SCOTT'S PLACE SUBDIVISION

APPLICATION NUMBER 12 DATE August 7, 2008

REQUEST Subdivision

DETAIL SITE PLAN

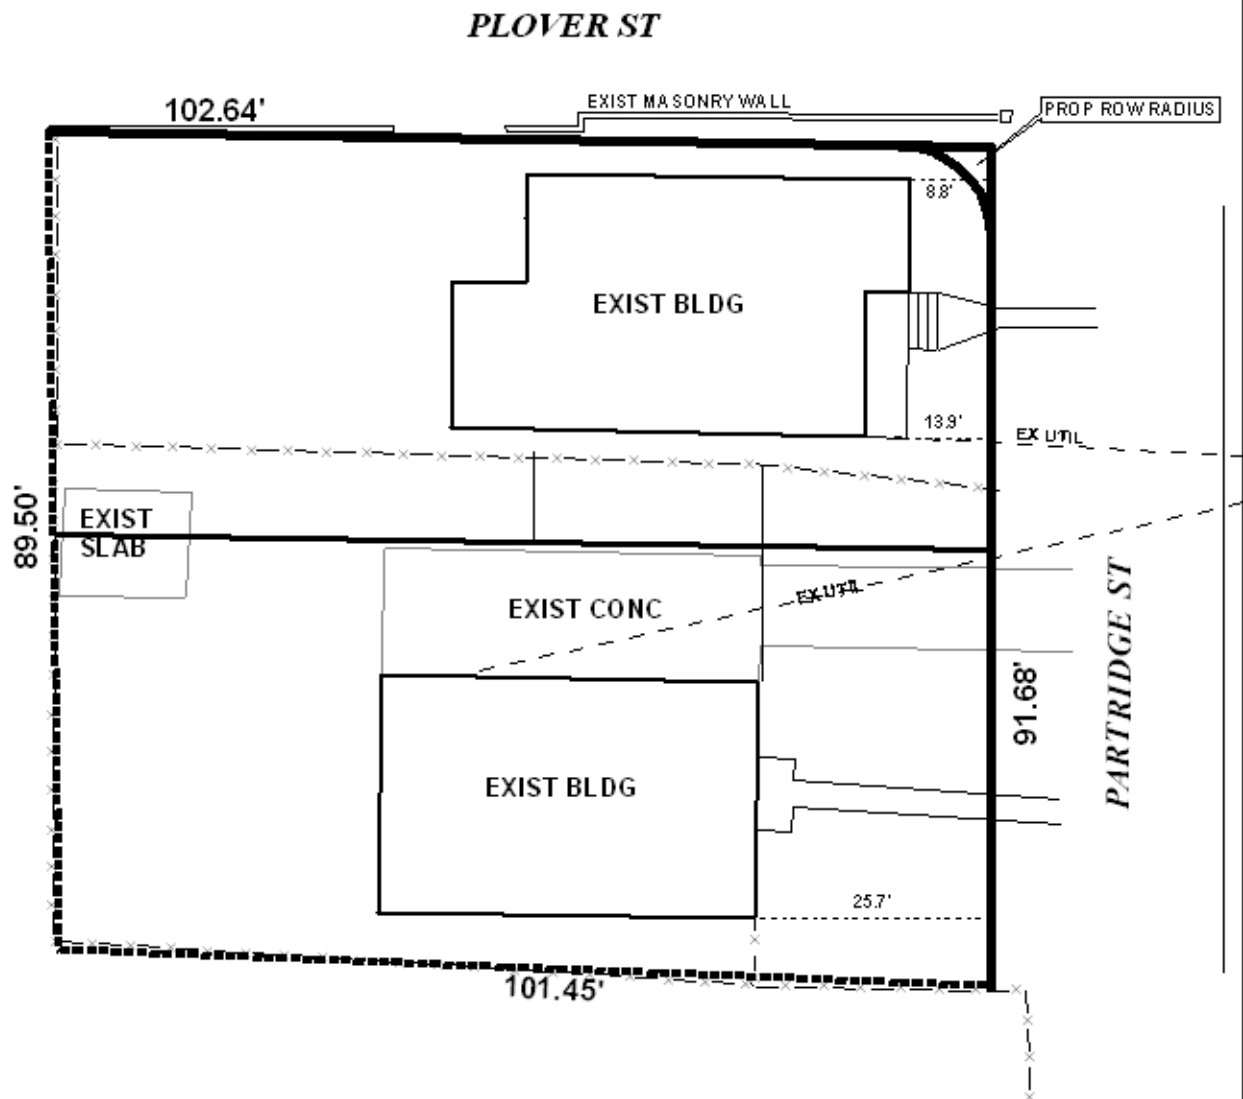
While approval will require side and front setback waivers, the existing structures are already non-conforming with the setback regulations. Approval of the proposed subdivision will neither alter nor worsen the existing non-conforming setbacks. The approval of the proposed lots will legitimize the homes on legal lots. It is recommended that the 25' minimum building setback line of the Subdivision Regulations be reduced in favor of those in the Zoning Ordinance; Lot 1, at 44' in width, is to have 25' in front, 8' in the rear, 8.4' on the side and 6.3 on the other side. Lot 2, at 47.69', is to have 25' in front, 8' in the rear, 6.9' on the side and 9.1' on the other side. Any future development of either lot must meet the required setbacks. In addition, the required setbacks should be shown on the final plat.

Proposed Lot 1 fronts both Partridge Street and Plover Street while proposed Lot 2 fronts Partridge Street. Both streets appear to have adequate right-of-way width of 50' however, there appears to be a masonry wall in the right-of-way to the North of proposed Lot 1. The wall should be demolished (with proper permits) prior to the signing of the final plat or a permit from right-of-way should be obtained.

Proposed Lot 1 would have approximately 44' of frontage along Partridge Street and approximately 100' of frontage along Plover Street. Proposed Lot 2 would have approximately 45' onto Partridge Street. As a means of access management, a note should be placed on the final plat stating that the proposed Lot 1 is limited to one curb cut to Partridge Street and denied access to Plover Street, while proposed Lot 2 is limited to one curb cut onto Partridge Street with the size, location and design to be approved by Traffic Engineering and conform to AASHTO standards.

- 1) Placement of a note on the final plat stating that any new additions must meet all required setbacks;
- 2) Revision of the plat to show the Zoning Ordinance setbacks

- Lot 1: Front Setback: 25 feet
 - Rear 8 feet
 - Side(street) 8.4 feet
 - Other Side 6.3 feet
 - Lot 2: Front Setback: 25 feet
 - Rear 8 feet
 - Side(min.) 6.9 feet

- Side(other) 9.1 feet
- 3) Demolition of the masonry wall to the North of proposed Lot 1 or obtainment of a permit for the wall prior to the signing of the final plat;

- 4) Placement of a note stating that Lot 1 is limited to one curb cut onto Partridge Street and denied access to Plover Street, while Lot 2 is limited to one curb cut onto Partridge Street with the size, location and design of all curb cuts to be approved by Traffic Engineering and conform to AASHTO standards; and
